Westinghouse Electric Company LLC
Nuclear Fuel
5801 Bluff Road
Hopkins, South Carolina 29061-9121
USA

Your ref: 70-1151/2016-005
Our ref: LTR-RAC-17-40

SUBJECT: WESTINGHOUSE SNM-1107 UPDATED RENEWAL LICENSE APPLICATION

Westinghouse Electric Company LLC (Westinghouse) is pleased to submit the enclosed SNM-1107 updated license renewal application. This updated application incorporates the following changes since the initial renewal application dated December 17, 2014.

Figure 10.1 Locations of Air, Vegetation and Soil Monitoring Stations

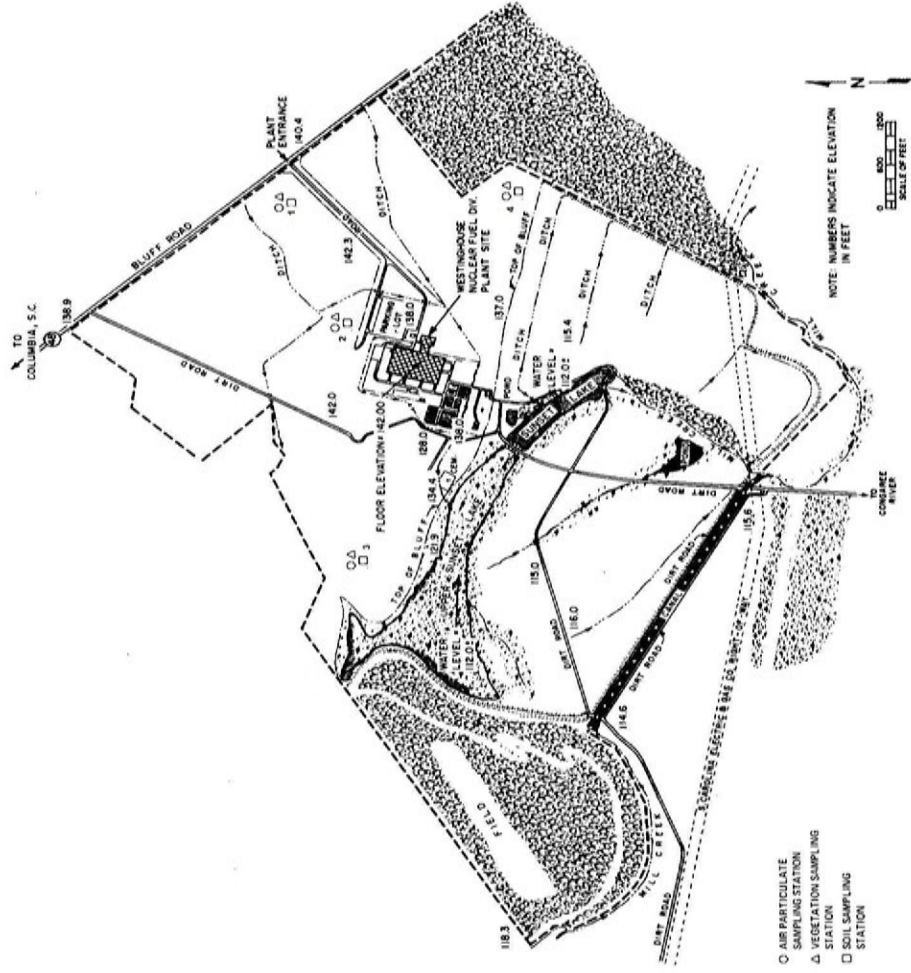
12. Revised Figure 10.1; added the schedule for groundwater monitoring; and added a requirement in Section 10.1.5 to submit an annual groundwater report as per our discussions during your site visit on September 7, 2017. (Note that Figure 10.4 "Locations of Monitoring Wells" and the
